**Final**  
**Environmental Impact Report**  
**500-year Flood Protection Project**

**State Clearinghouse No. 2021070157**

April 2022

## Chapter 2. Comments and Responses to Comments on the Draft EIR

Figure 2-12. Goldfields West Levee and Yuba River South Levee Project Components

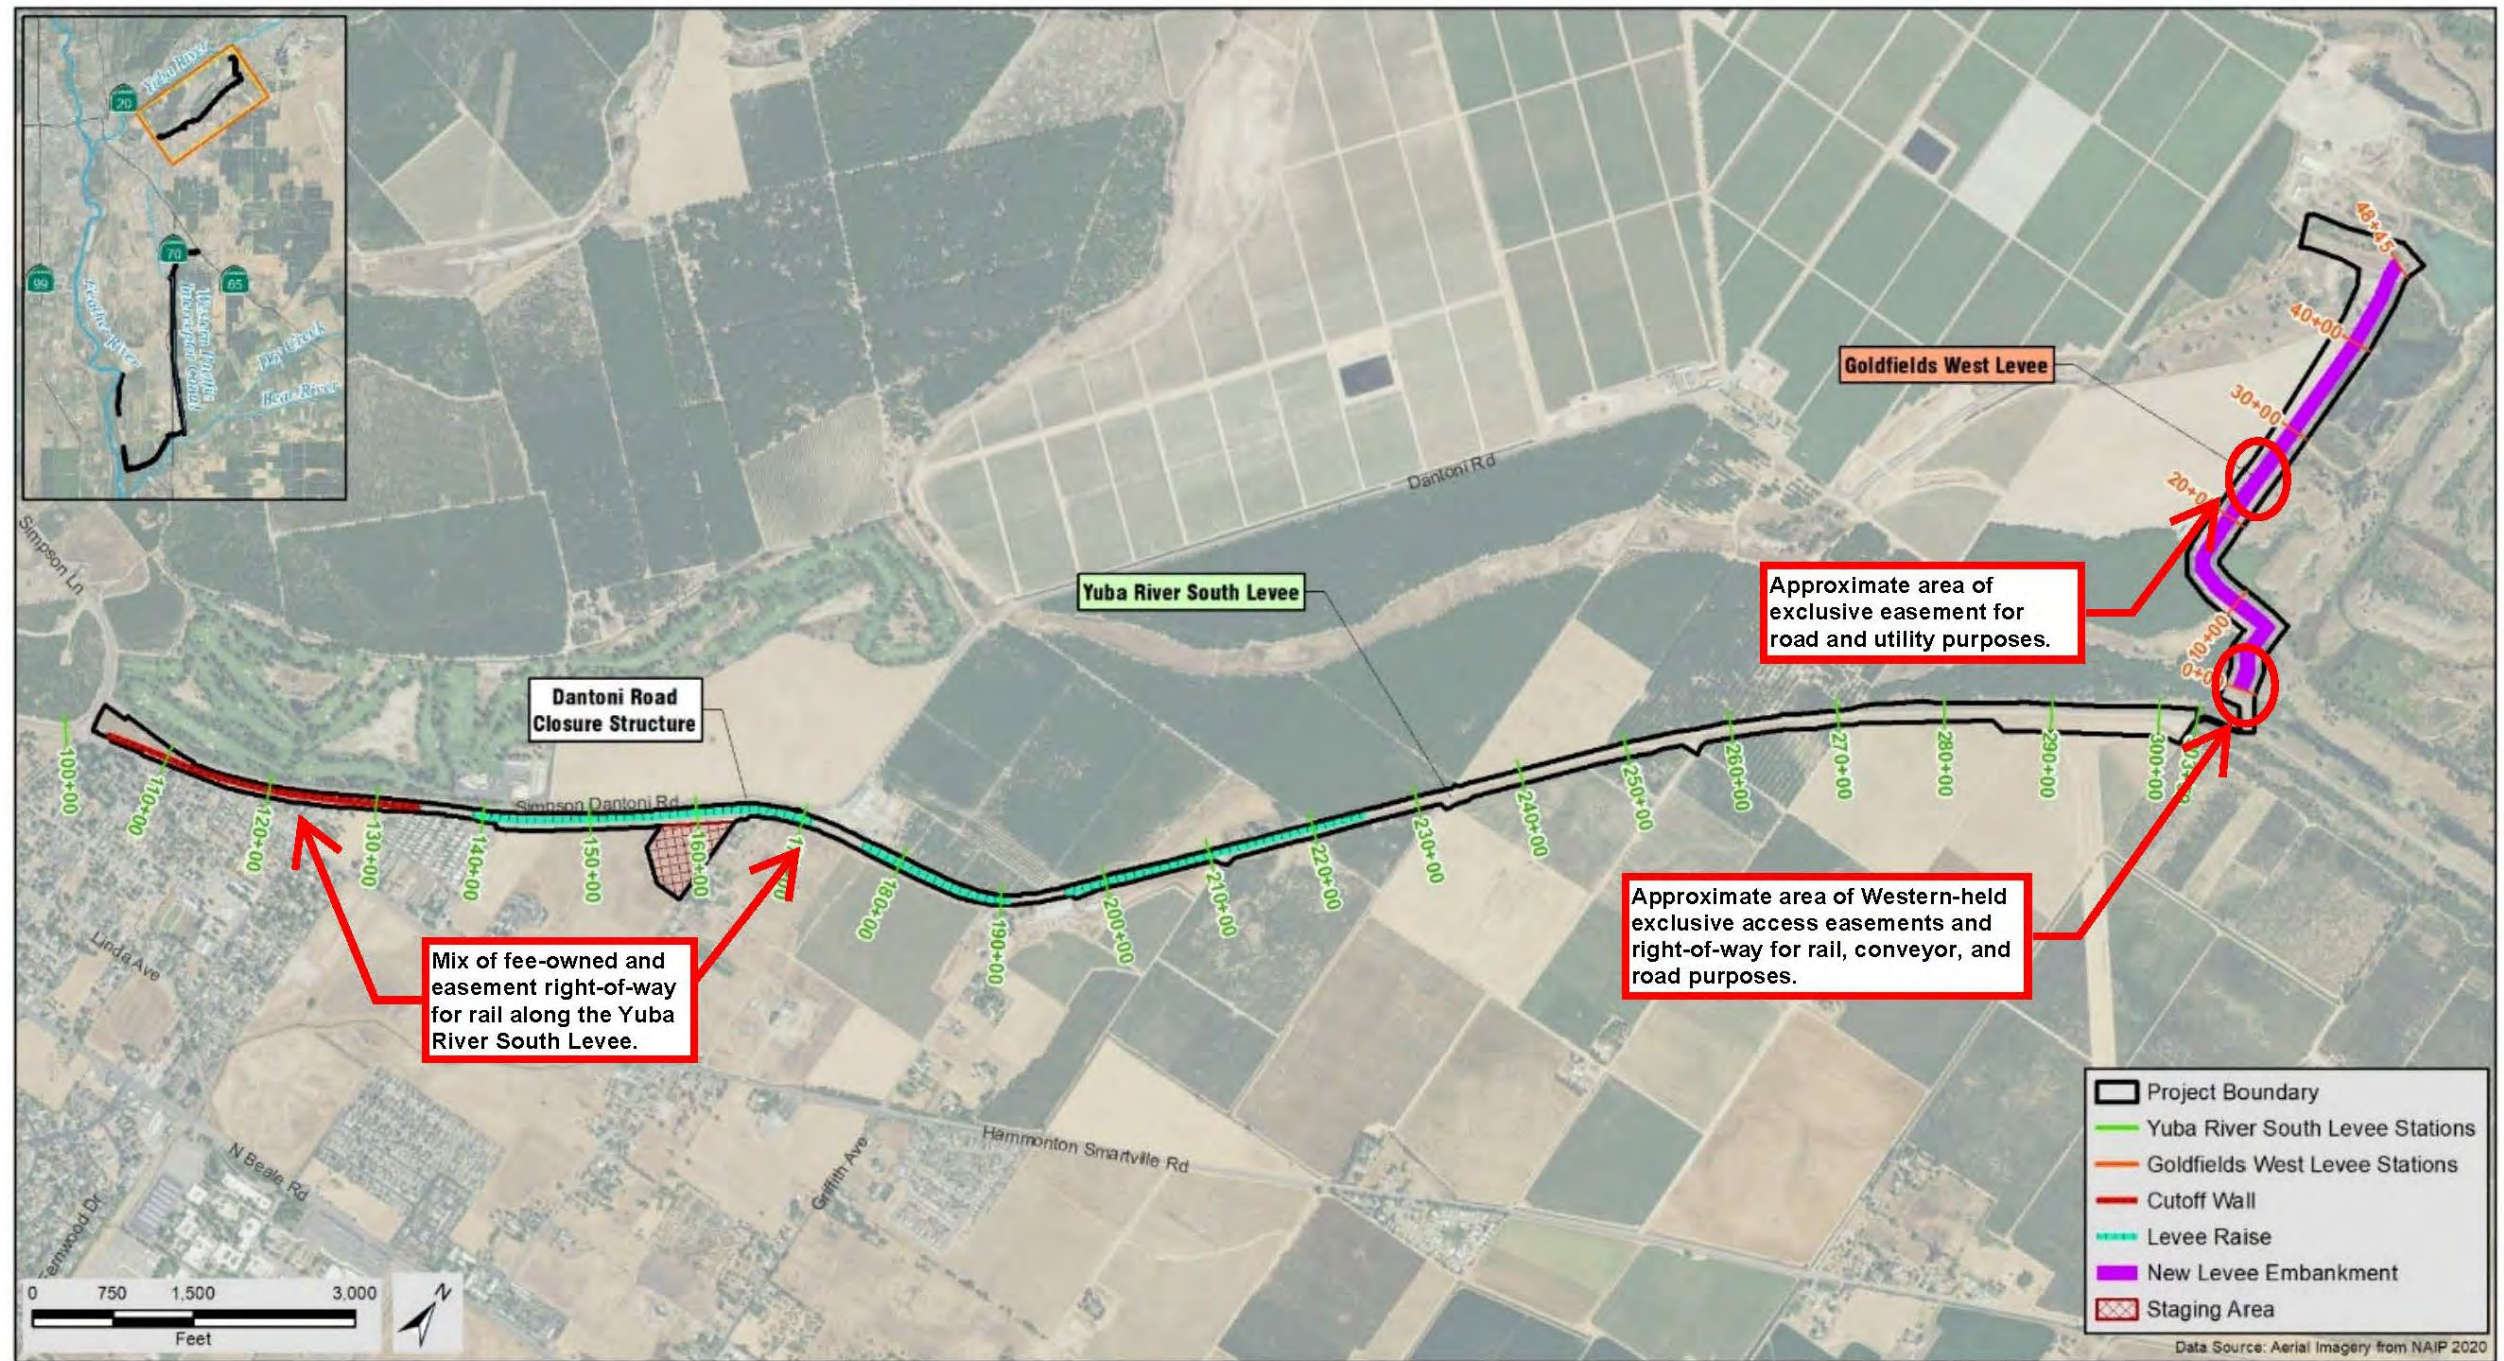
avoid abridging them. These rights-of-way interests and access easements, which historically have accommodated rail lines, comprise important elements of the overall existing and future operations of the Goldfields, and their alignments cross the proposed Goldfield West Levee and run atop the existing Yuba River South Levee system, along Simpson and Dantoni Roads. These alignments appear to match those of the proposed Cutoff Wall and levee height increases, and the proposed Goldfields West Levee appears to cross two other exclusive (to Western) easements that also contain rail and road alignments. We have indicated the approximate locations of these fee and easement rights-of-way and access easements in a markup of DEIR Figure 2-12, provided as Attachment “A” to this letter.

The DEIR does not appear to disclose or evaluate the existence of any of these fee or easement rail rights-of-way and access easements,<sup>1</sup> and also does not evaluate the potential of the Project either to disrupt, alter, or permanently remove them. As stated above, this access is critical to the ongoing operation of the Goldfields, as it allows Western to provide an important means of transporting the mined materials. The removal or substantial disruption of this access would substantially affect these ongoing operations: the DEIR must evaluate the associated effects on mineral and aggregate production. It does not do so, and that failure deprives decisionmakers and the public of information that would allow an informed discussion of the relative benefits and adverse impacts of the Project. Further—and together with the impacts to mineral and aggregate resources described above—this failure deprives the conclusions of the DEIR regarding impacts to mineral resources of any evidentiary support, let alone substantial evidentiary support. TRLIA must revise the DEIR provide this analysis, and must recirculate the DEIR to permit informed comment and participation in the EIR process.

TRLIA is aware of Western Aggregates' fee and easement rail rights-of-way and access easements referenced in the comment letter. The proposed

project would not disrupt or permanently remove these interests or easements. Improvements to the Yuba River South Levee would result in very minor modifications to the existing levee that would not disrupt or remove Western Aggregates' access rights. Constructing the Goldfields West Levee would involve modifying an existing tailing feature and would not create a new access issue. It is a common occurrence to construct ramps over flood protection embankments to continue or enable access to areas on both sides of an embankment. Therefore, constructing the Goldfields West Levee would not remove Western Aggregates' access rights and would not block access to areas of existing or future operations or means of transporting mined materials. Because there would be no such impact that requires disclosure, the EIR provides sufficient information to comply with CEQA.
